Subject: Facility Response to Request for Additional Information (Acc. # ML16189A194)

On August 11, 2016, the NRC sent a Request for Additional Information (RAI) to Kansas State University nuclear reactor facility (license R-88, docket 50-188) regarding a license amendment request originally submitted on April 9, 2012 (Acc. # ML12109A063).

Figure 1 - Photo of reflector / grid plate assembly from GA-3399, showing space between grid plate and reflector.

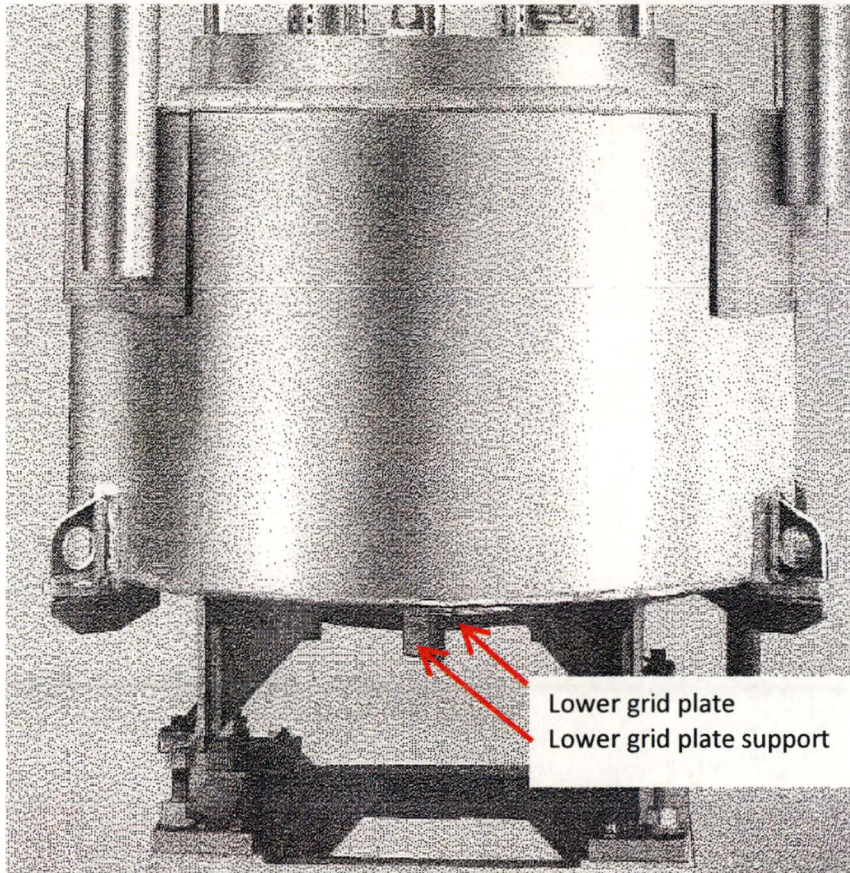
1. SAR Section 4.2.5, "Core Support Structures," states "The bottom grid plate, which supports the weight of the fuel elements, has holes for receiving the lower end fixtures. Space is provided for the passage of cooling water around the sides of the bottom grid plate and through 36 experiment penetrations. The 1.5 in. (3.8 cm) diameter holes in the upper grid plate serve to space the fuel elements and to allow withdrawal of the elements from the core. Triangular-shaped spacers on the upper end fixtures allow the cooling water to pass through the upper grid plate when the fuel elements are in position. The reflector assembly supports both grid plates. Provide the drawings of the core support and other structures. Also provide documentation describing the flow path geometry around the side of the bottom grid plate.

2. The description of the flow geometry in the license amendment request is primarily based on the mechanical maintenance manual, GA-3399, "250-kW TRIGA Mark II Pulsing Reactor Mechanical Maintenance and Operating Manual." The corresponding section from the manual is attached as Attachment 1. The flow path geometry between the bottom grid plate and the reflector is almost totally unobstructed by structural components. The bottom grid plate is held by small L-shaped brackets. These are shown in an un-numbered shop sketch, attached as Attachment 2. This sketch also specifies that the reflector aluminum is $\frac{3}{8}$ " thick. Figure 1 is a photo from GA-3399 which depicts the gap between the lower grid plate and reflector.

Figure 2 - ANSYS model of coolant pressure drop for TRIGA reactor operating at 1250 kW.

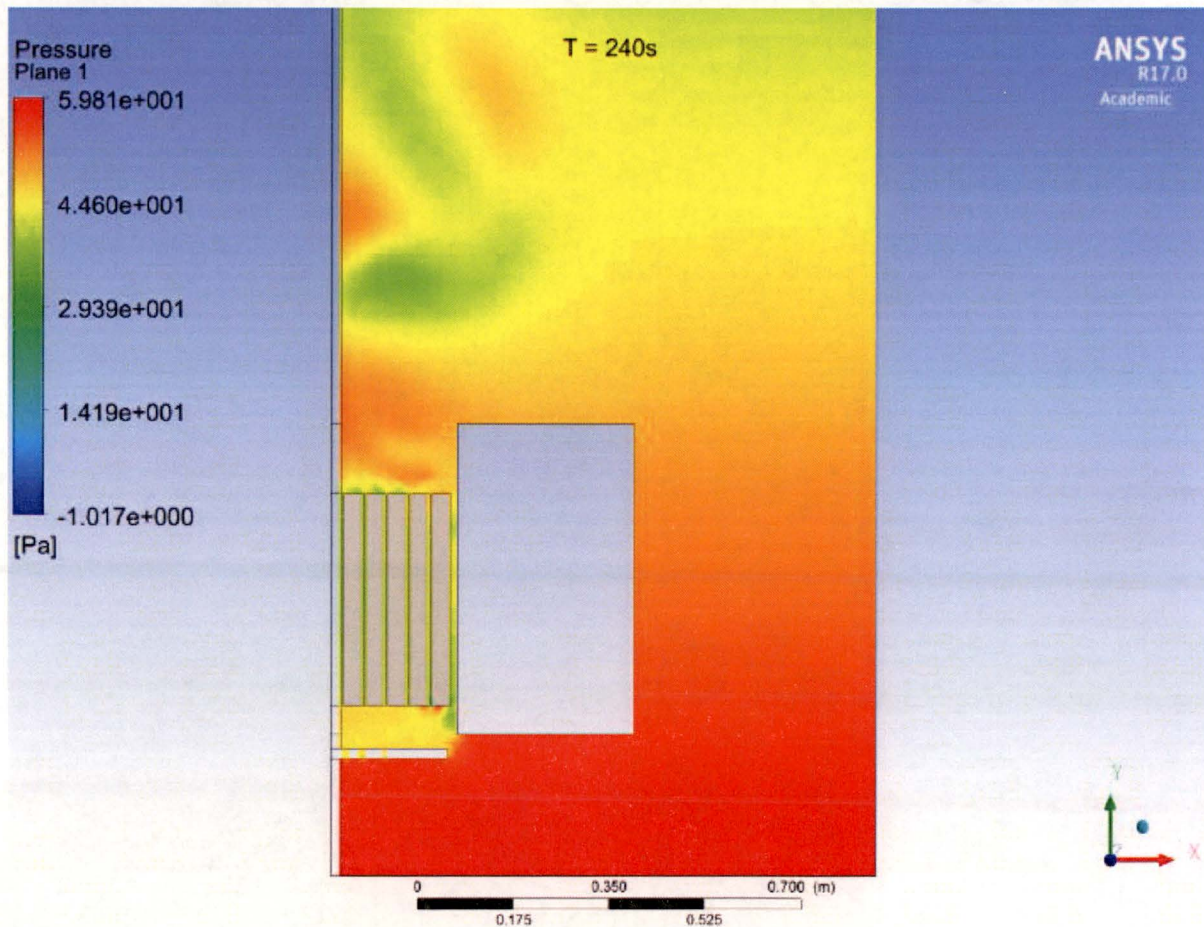
3. The loss coefficient for the core exit is calculated on page 4-26 of the SAR to be 0.171. It is described as a contraction loss. The actual flow will undergo a contraction followed by an expansion when flowing through the grid plate. Provide the basis for the formula used to calculate the core exit loss coefficient.

The exit pressure loss, $\Delta P_e = \frac{K_e \rho v_e^2}{2}$, is based on the downstream flow velocity (v_e). Since the velocity of the coolant exiting the core is very low, this expansion loss was ignored. Supporting calculations were performed using a TRIGA core model in ANSYS, for an operating power level of 1250 kW. These calculations show (see Fig. 2) that the pressure drop for coolant leaving the core of ~20 Pa, i.e., much less than one atmosphere.

Figure 3- Axial temperature profile of reactor coolant in B-ring using RELAP calculations

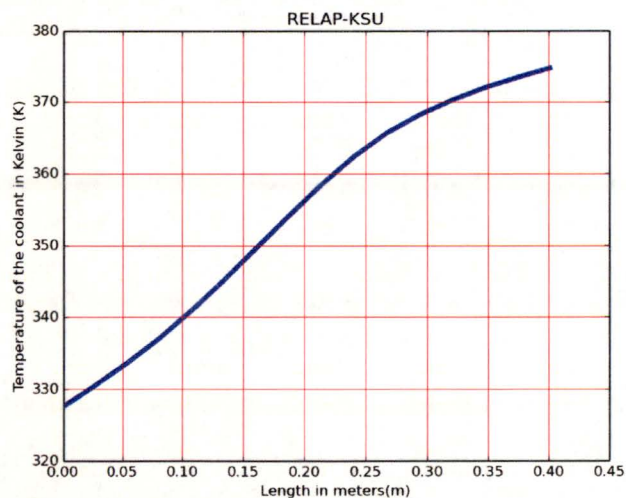
5. According to SAR Section 4.6, the calculation for core flow rate vs. power uses a core inlet temperature of 27 degrees Celsius and uses an equation that is applicable only to single phase flow. Are the pool temperature limits designed to ensure that single phase flow exists across the core?

The coolant temperature limits are designed to prevent damage to the ion exchange resin used to maintain low primary water conductivity, not to ensure single phase flow. GA TRD 070.01006.04, "TRIGA Reactor Thermal-Hydraulic Design Study" (2008) contained a RELAP and STAT and concluded that the three 1 MW TRIGA cores analyzed in the study would not experience nucleate boiling at their design temperatures, and the void fraction at a 2 MW TRIGA considered in the study would be 1.5% for an 86°F inlet temperature. This inlet temperature is slightly higher than the 27°C temperature used in the KSU SAR, but is below the 130°F KSU Tech Spec limit on water temperature (130°F = 54.4°C).

Calculations performed at KSU in support of this RAI response indicate that the reactor would reach nucleate boiling at 1250 kW for the power peaking assumed in the SAR (2.0), but would have several degrees of margin to nucleate boiling at more realistic power peaking factors calculated with MCNP. MCNP calculations were used to obtain volumetric heat generation rate in the maximum power B-ring fuel rod. A validated RELAP model was modified with this input heat generation rate and KSU tech spec limit as inlet temperature. The calculations were used to evaluate axial profile of coolant temperature (shown in Fig. 3). The outlet temperature of coolant was computed to be 101°C. This is above the boiling point of water at standard temperature and pressure, but slightly below the boiling point of water at the core depth of ~5 meters below the surface of the water.

Figure 4 - ANSYS calculation of coolant flow velocity through the KSU TRIGA reactor core when operating at 1250 kW.

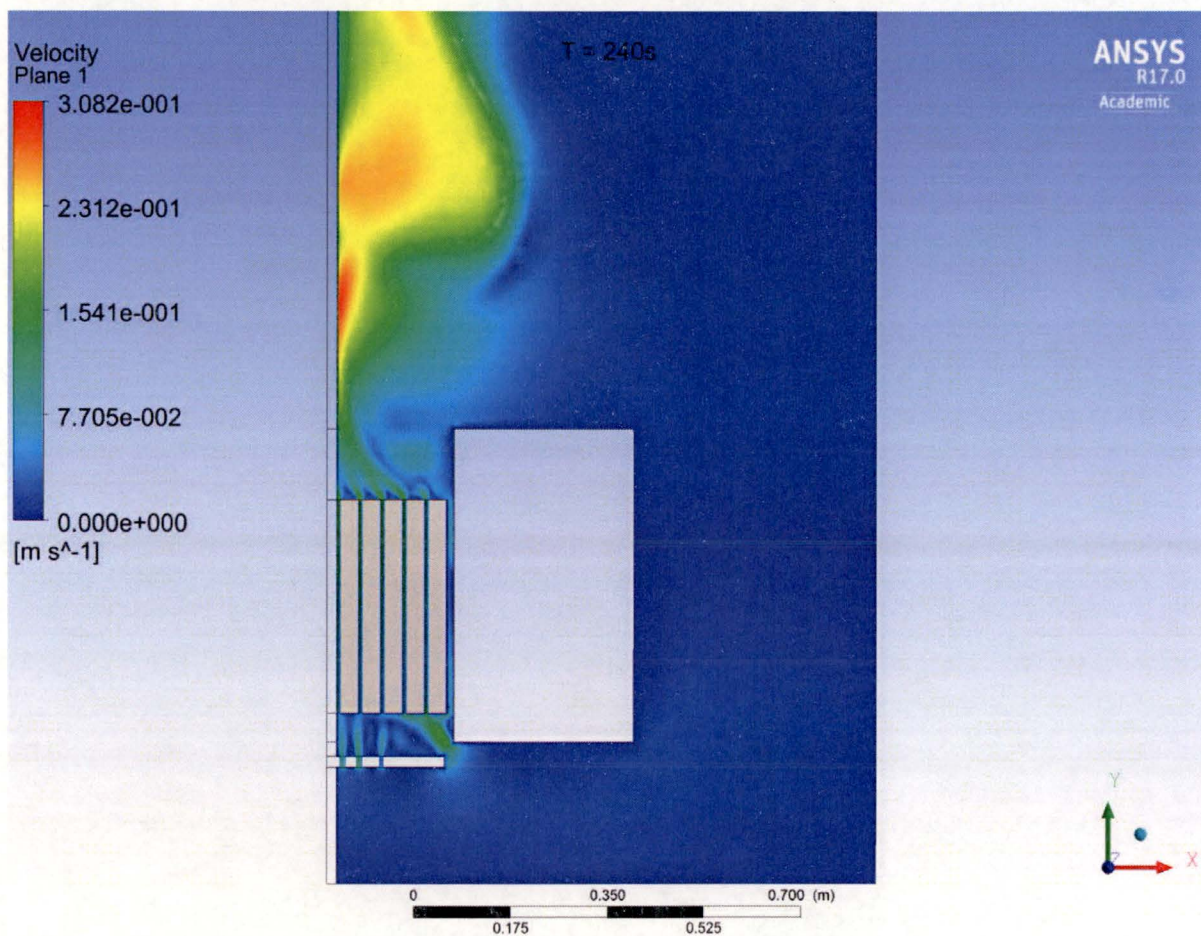
6. SAR Section 4.6 states that the entrance of coolant into the core is from the side, above the lower grid plate (see Section 4.2.5) and the entrance pressure loss would be expected to be negligible. There is no basis for this statement. Provide the basis.

As indicated by the ANSYS model shown in Figure 4, the pressure drop above the grid plate is on the order of 20 Pa. These calculations also indicate that the majority of the coolant flow into the core will be from the side, which is the path of least resistance for the coolant. (See Fig. 4). These results are consistent with the pressure loss model in SAR report which models the overall flow resistance to be harmonic mean of flow resistance across the grid plate and flow resistance across the side gap between grid plate and reflector. Due to larger opening size, flow resistance through the side gap is negligible and thus most of the coolant is expected to flow through the side.

Figure 5 - Effect of fuel radius adjustment on power peaking.

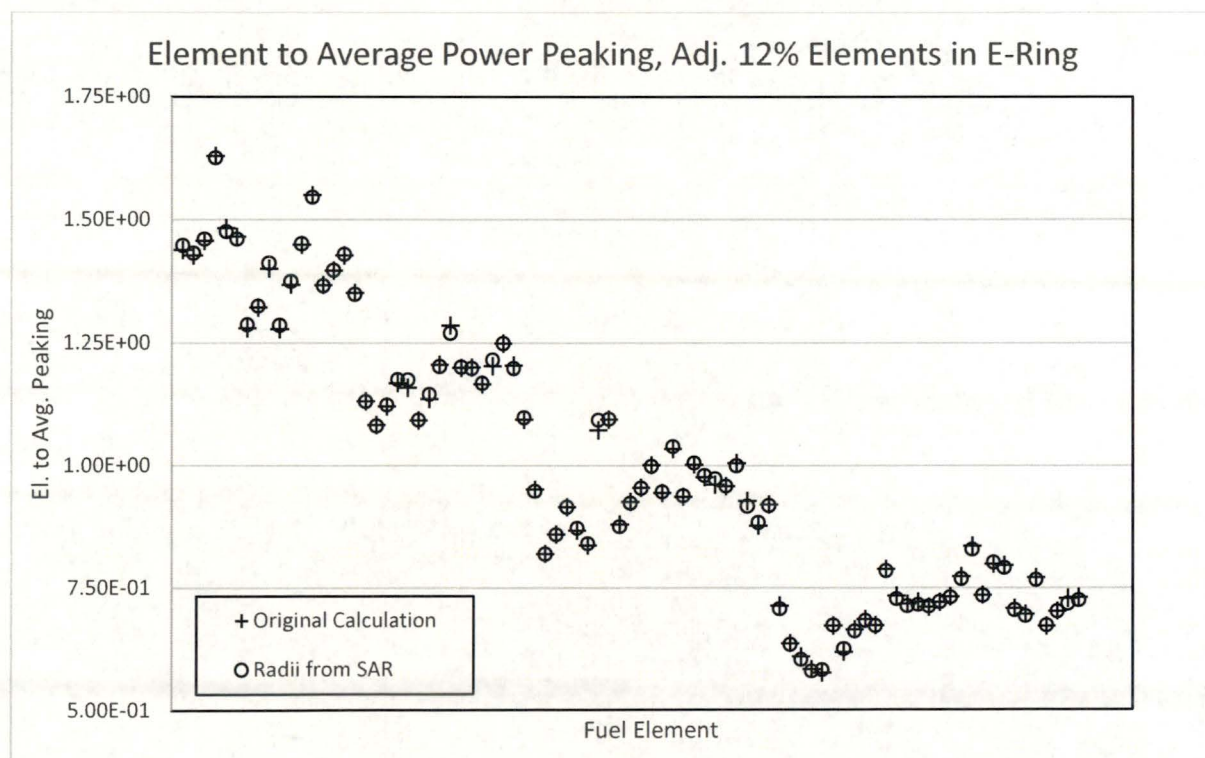
6. The NRC staff wants to reconcile the fuel pin cylindrical radii given in surfaces 200 through 202 with what they were able to calculate from the SAR and some of the cited reference that describe Mark III fuel. The NRC staff arrived that the following values for pin radii: middle zirconium rod (0.3175 cm); fuel-moderator material (1.8161 cm); gap (1.8415 cm); and clad (1.8669 cm). Supply the basis for the dimensions given in Surfaces 200 through 202.

No gap was modelled between the fuel meat and cladding; the void inside the fuel element was only modelled above the axial graphite reflector. The radii used in the model seem to be slightly off from the values in the SAR and other references. In order to verify that this did not significantly impact the safety basis for the addition of new fuel, one of the modeled cases was repeated with the fuel meat and cladding radii adjusted to exactly match the values in SAR Table 13.1, fuel radius = 1.8161 cm and clad outside radius = 1.8669 cm. The case that was re-modeled featured two adjacent 12%-loaded elements in the E-ring. As a result of this adjustment, the element to average power peaking changed minimally, with the greatest increase in calculated power peaking being an increase of +1.9% for element E-7 (one of the 12%-loaded elements). As can be seen from the results, the change in calculated power peaking that results from correcting the fuel feature radii is minimal and does affect the determination that 12%-loaded elements in the E- and F-ring will have a much lower power peaking and fission product density than 8.5%-loaded elements in the B-ring. The adjustments that were made to the fuel radii in the model were also incorporated into further revisions to the model that were made to address later questions in the RAI.

Figure 6 - Updated power peaking calculation from MCNP, based on F7 tally.

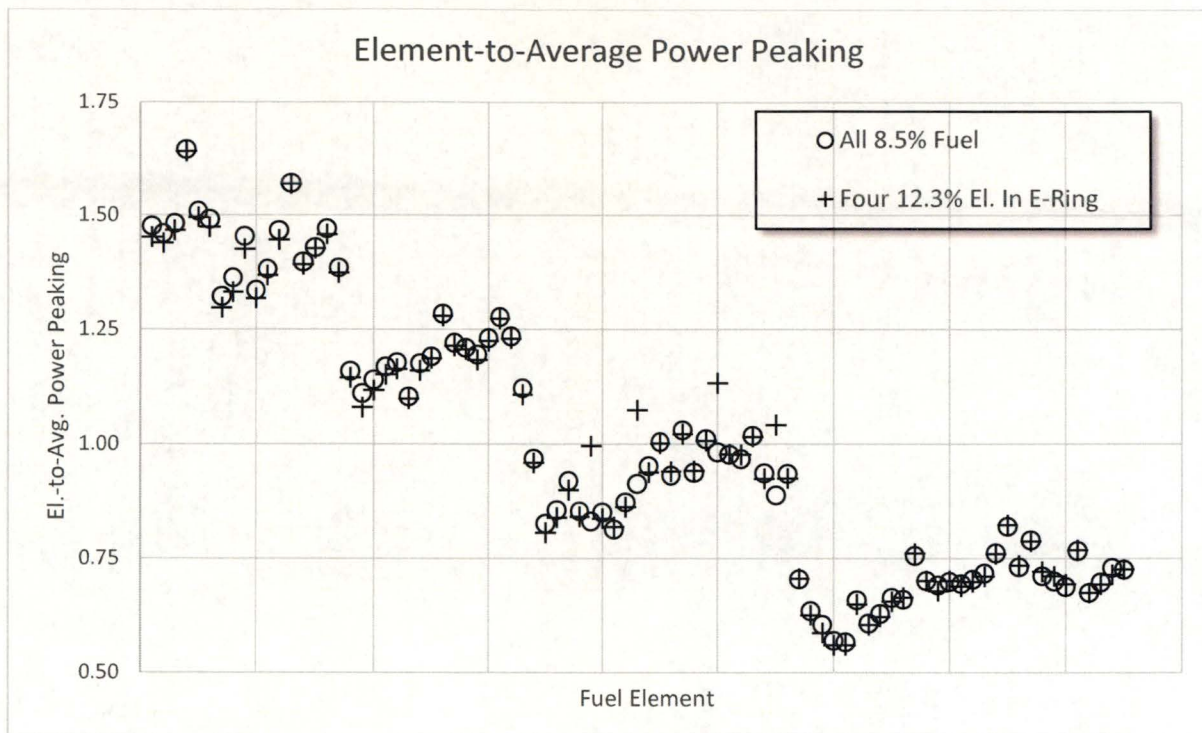
10. In RAI No. 1 of the KSU RAI response, KSU gives a methodology for determining the change in Uranium-235 mass with burnup (initial fuel composition minus the burnup per element). Provide the composition of the maximum burnup element that is calculated through this methodology.

The corrected fuel radii and depleted fuel compositions led to slight difference in the model results. The updated model also included a revision to the RSR inner and outer radii, which were previously set to 26" (inner) and 30" (outer), but should have been 24" (inner) and 28" (outer). The difference in reactivity for the base model and model with four 12% elements changed as follows:

The maximum element-to-average power peaking due to the addition of four 12% elements in the E-ring was found to change as follows. Note that the four elements were placed in the same E-ring locations as in the original LAR-supporting calculations. These results are compared to the 12.3%-load case from the original work, since the 12% elements in the revised model were given a loading corresponding to the maximum load of 12% fuel on hand at KSU, which is approximately 12.3% uranium by weight. The reactivity effect of adding the 12% fuel is calculated to be higher based on the revised model; however, the calculation does not show that the minimum safety shutdown margin, which at present is approximately \$2.60, will be challenged.

Figure 6 shows the power peaking for the updated MCNP model, with all 8.5%-loaded fuel (i.e., current license) versus a core with four 12.3% elements in the E-ring.
